**City of Portland, Maine – Building or Use Permit Application** 389 Congress Street, 04101, Tel: (207) 874-8703, FAX: 874-8716

Location of Construction: 140 Reed Avenue, Peaks Island		Owner: Steven & Kimberly MacIsaac		Phone: 773-3527		Permit No: <b>960318</b>	
Owner Address:		Leasee/Buyer's Name:		Phone:		BusinessName:	
Contractor Name: John Kiely		Address: Island Ave, Peaks Island		Phone:		<div style="border: 2px solid black; padding: 5px; text-align: center;"> <b>PERMIT ISSUED</b>                  Permit Issued:                  APR 26 1996  <b>CITY OF PORTLAND</b> </div>	
Past Use: Single family dwelling		Proposed Use: single family dwelling w/interior-exterior reno		COST OF WORK: \$ 55,000.00 PERMIT FEE: \$ 295.00		FIRE DEPT. <input type="checkbox"/> Approved <input type="checkbox"/> Denied INSPECTION: Use Group: <i>H3</i> Type: <i>574</i> <i>DOCS 47</i> Signature: <i>[Signature]</i>	
Proposed Project Description: Renovations as per plans				PEDESTRIAN ACTIVITIES DISTRICT (P.U.D.) Action: Approved <input type="checkbox"/> Approved with Conditions: <input type="checkbox"/> Denied <input type="checkbox"/> Signature: _____ Date: _____		Zoning Approval: <i>[Handwritten]</i> Zone

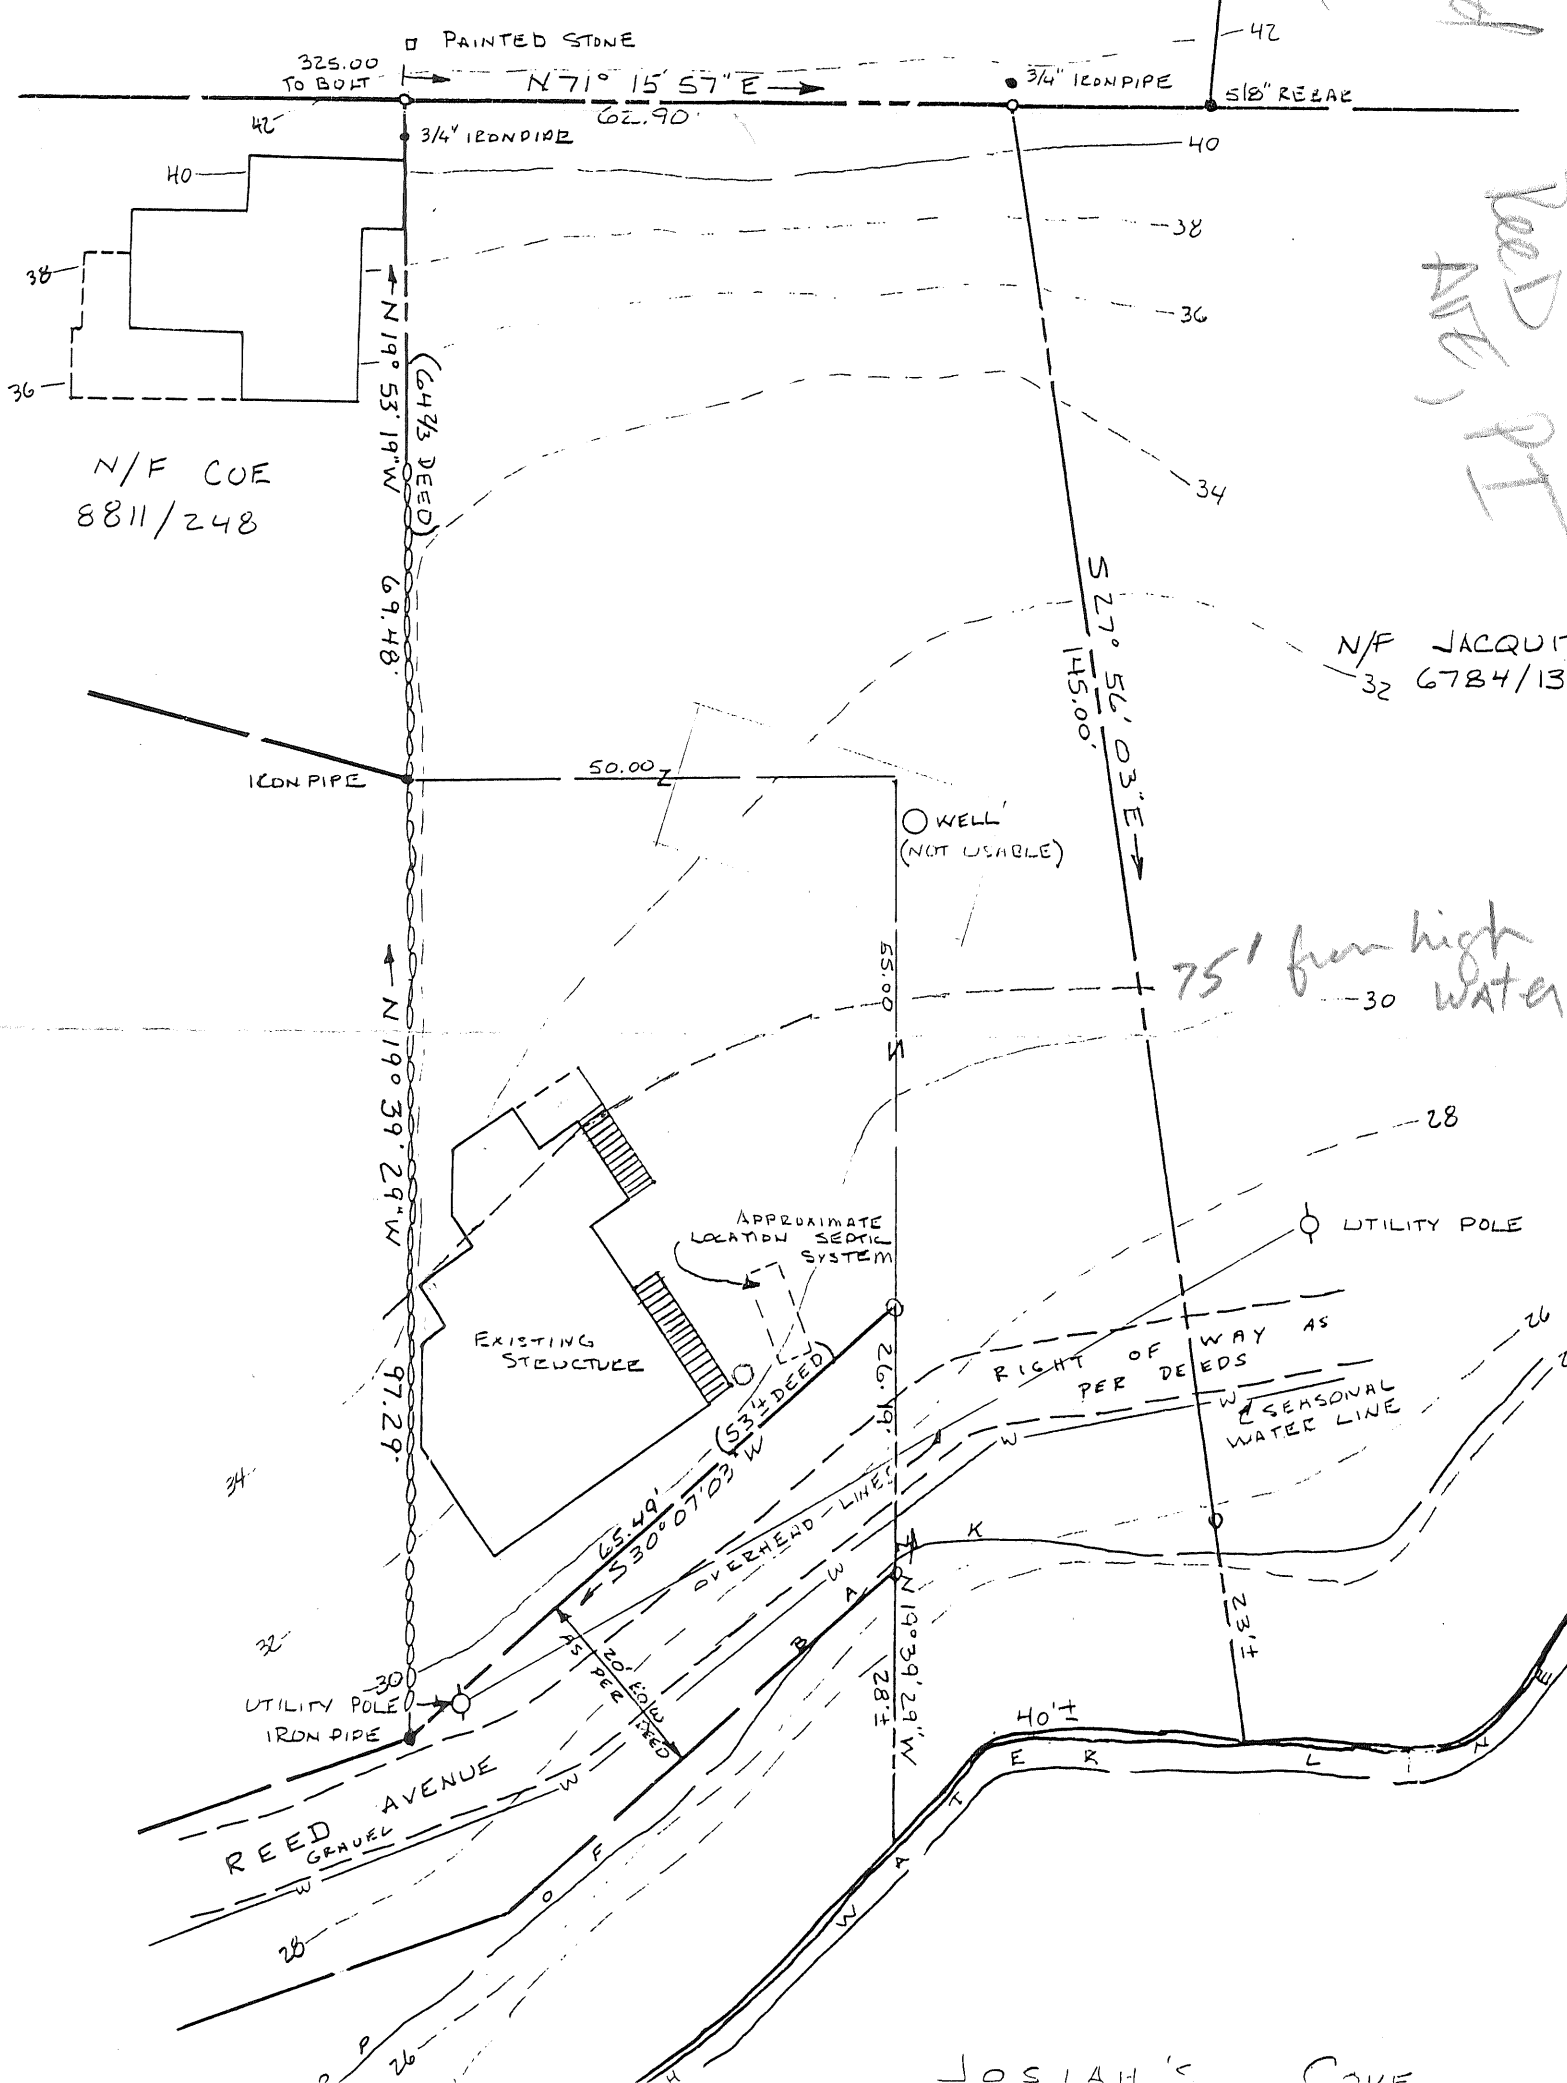
Date - existing  
Zone Location - IR-1  
Interior or corner lot -  
Use - single Family Home - relocating & expanding  
Sewage Disposal - Private - relocating - see HAE 200  
Rear Yards - 30' req. - 30' + shown  
Side Yards - 20' req. - is decreasing the setback from the legal  
Front Yards - 30' req. - NON conformity which was on line  
Projections - SAME AS ABOVE - less encroaching  
Height - 2 story - 35' MAX - ok per submitted  
Lot Area - 40,000<sup>sq</sup> ft -  
Building Area - MAX 20% of Lot Area  
Area per Family -  
Width of Lot - 100' req.  
Lot Frontage - 100' req.  
Off-street Parking -  
Loading Bays - N/A

→ is within 75' shoreland setback -  
If meets the requirements of the 30%  
MAX. increase.

to figure the Compliance with the max 30% increase of floor area

**OLD House**  
only area within 75' line (old line)

**New House**  
only area within 75' line (old line)

1709.00\$  
Amend.  
They changed their design

compare  
1709.00  
- 1412.16

296.84\$ over the MAX

Thus The house was rotated (see new plans) in order to get more of the new structure out of the 75' shoreland setback line - another 336\$ is now rotated out of the 75' setback - which approves this requirement

Address: 140 Reed Avenue  
Prakes Island Maine

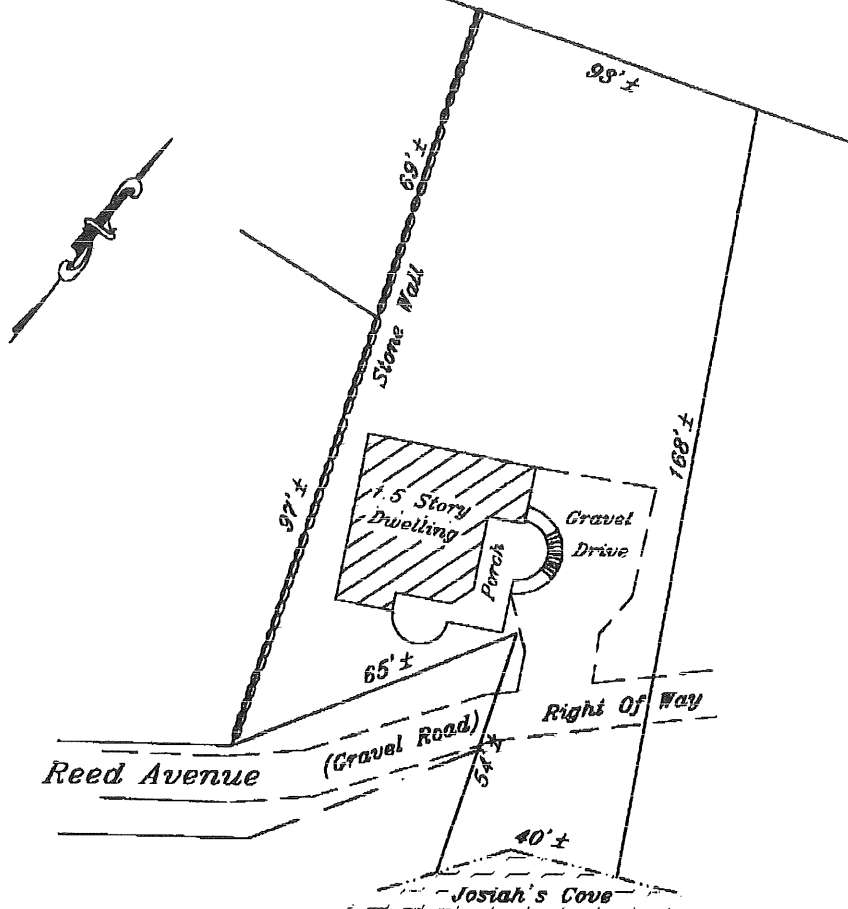
The dwelling does  fall within a Special Flood Hazard Zone Per Fema Community Map No. 230051  
Panel: 9B Zone: V2 Date: 12-8-98

Comments: Recommend Elevation Certificate.  
The above dwelling appears to be closer to the shore than the original non-conforming grand fathered dwelling it replaced.
